### INSPECTOR'S REPORT ON AN APPLICATION FOR A CERTIFICATE OF AUTHORISATION FOR A CLOSED LANDFILL

**RE:** Application by **Monaghan County Council** for a Certificate of Authorisation for a closed landfill at **Killycard, Castleblayney, County Monaghan**.  
Certificate of Authorisation Register Number **H0364-01**.

**Figure 6: Groundwater/gas monitoring borehole (GW) and trial pit (TP) locations**

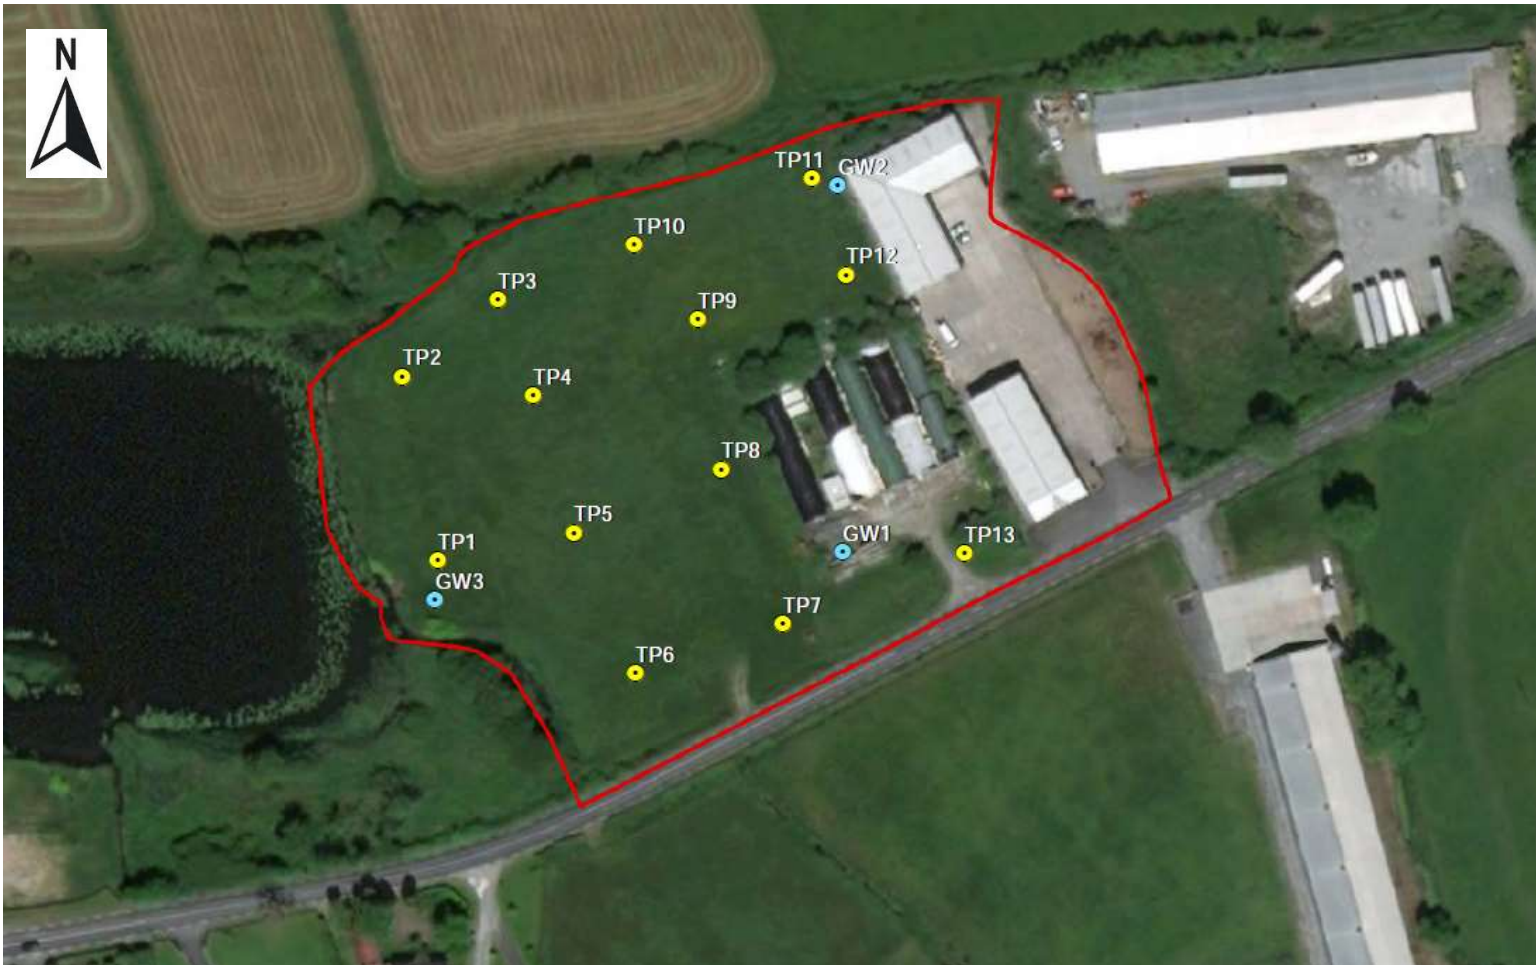
Leachate and water quality:	<p>Trial pits investigation at thirteen locations, as shown in Figure 6, established that made ground comprising waste was encountered in all trial pits and that groundwater was encountered in ten trial pits. The investigation further established that the cover material at these trial pits comprised 0.05m to 0.10m topsoil and waste was encountered between 0.1m – 3.4m in all trial pits. Natural ground comprising of cut-over peat and glacial till was confirmed in all trial pits except for TP11 where Made Ground was underlain by glacial till.</p>

<p>Three boreholes (GW01, GW02 and GW03) were installed within the waste body, as shown in Figure 6, to a total depth of 10m below ground level. Groundwater sampling results from these boreholes show coliforms and elevated concentrations of ammonia. Tier 2 Assessment states that given that all monitoring boreholes were installed within the waste body, as confirmed by the trial pit and geophysical findings, the landfill is contributing to a deterioration in groundwater quality.</p> <p>Tier 2 Assessment further states that presence of peat underlying the waste body across the site may also be contributing to the elevated ammonia concentrations in groundwater. The combined presence of coliforms and elevated ammonia concentrations in all monitoring boreholes, GW01 to GW03, may also be evidence of localised contamination due to agricultural land spreading or poorly functioning septic tanks in the area.</p> <p>The monitoring results also show elevated lead concentrations of 0.168 mg/l and 0.0743 mg/l at monitoring locations GW02 and GW03 and slightly elevated nickel concentration at GW01. Tier 2 Assessment states that the elevated concentrations of these parameters are considered to be evidence of the localised groundwater hydrochemistry based on the presence of historical lead mining north of Castleblayney.</p> <p>Condition 3.9(e)(i) requires monitoring on a quarterly basis of groundwater from at least three groundwater monitoring boreholes, one of which shall be upgradient of the waste body and two of which shall be downgradient of the waste body. Additionally, Condition 3.9(b) requires a quarterly monitoring for leachate.</p>

Tier 3 Assessment recommends quarterly groundwater monitoring at the existing monitoring locations GW01, GW02 and GW03 and two additional boreholes, one of which (GW04) is to be installed upgradient of the waste body and one borehole (GW05) is to be installed downgradient of the waste body. Considering however that the closed landfill is a high risk site (Category A), monitoring of groundwater from at least two downgradient locations, rather than one downgradient location, is regarded as appropriate. Accordingly, Condition 3.9(e)(i) requires monitoring of groundwater from at least three groundwater monitoring boreholes, two of which shall be located downgradient of the waste body and one of which shall be located upgradient of the waste body. Additionally, and to reflect the recommendations of Tier 3 Assessment, Condition 3.9(e)(ii) requires monitoring of groundwater from the existing wells GW01, GW02 and GW03 within the waste body. Condition 3.1(i) requires installation of the upgradient and downgradient boreholes.

**Figure 7: Area to be capped**

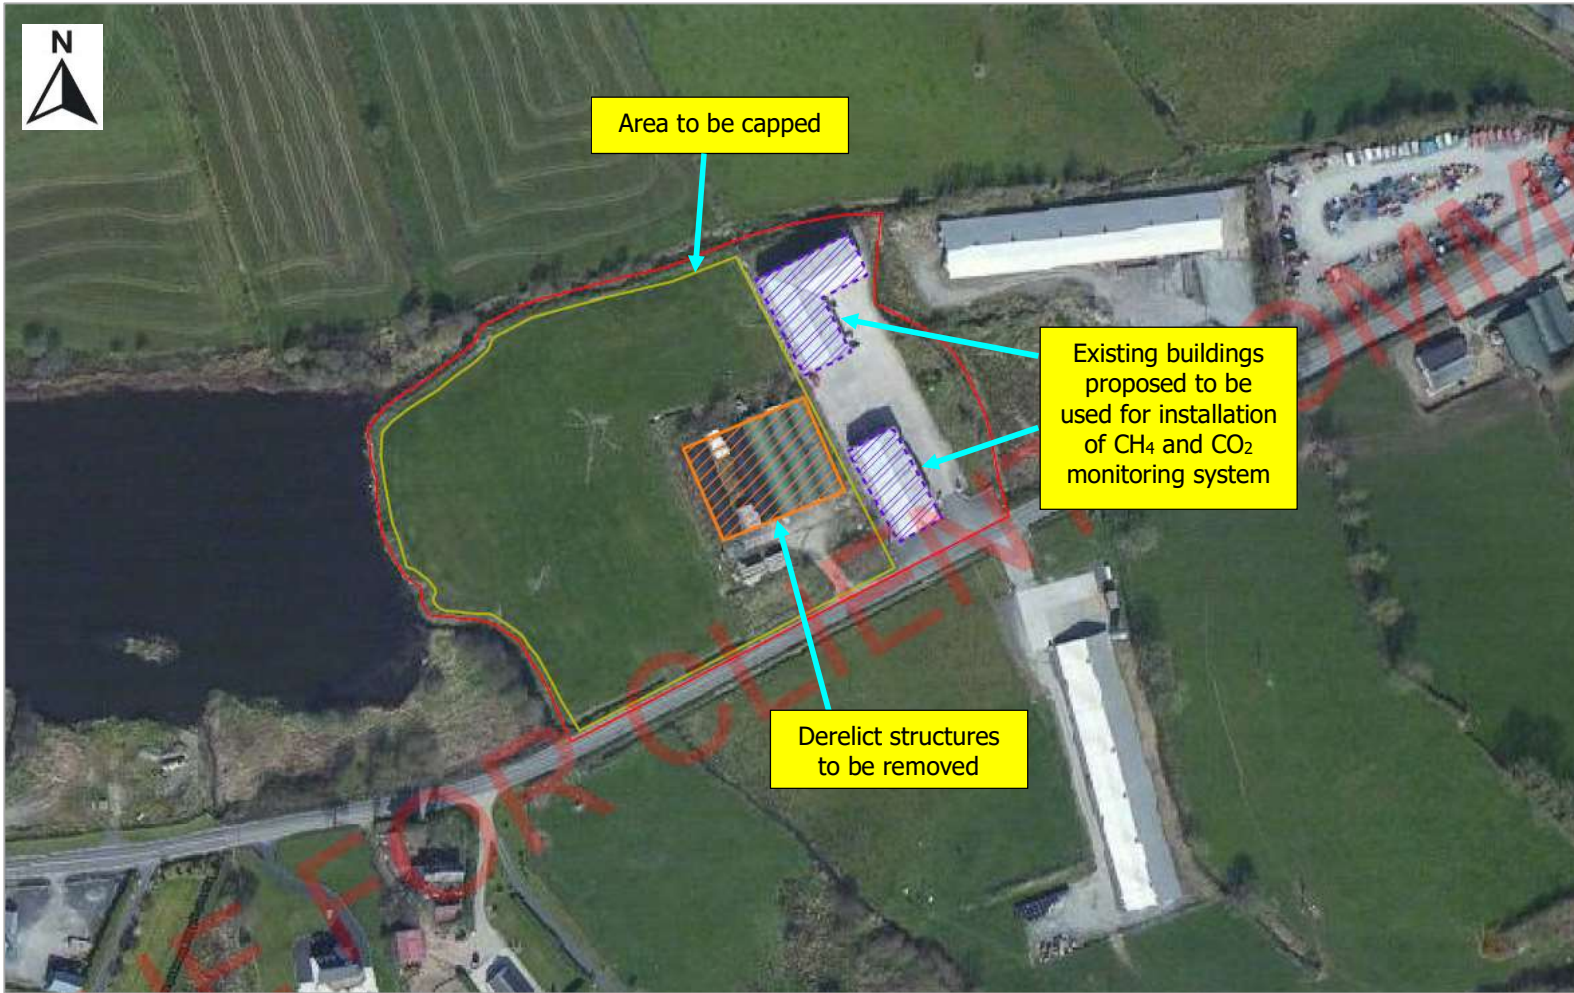
A landfill gas interception trench is recommended to be constructed along the eastern edge of the area to be capped (see Figure 7) and to the right of the two industrial units. Tier 3 Assessment states that the interception trench will comprise a deep vertical cut-off barrier to prevent lateral gas migration to the adjoining buildings and the barrier will be installed to a depth of 2m to 2.5m. It is noted however, that the made ground containing waste was found to be at deeper levels than 2.5m below the ground level. For example, made ground in

trial pit TP08 reached the depth of 4.4m below ground level. Accordingly, Condition 3.1(d)(i) requires that the base of the trench is constructed at the depth of the maximum depth of the waste body.
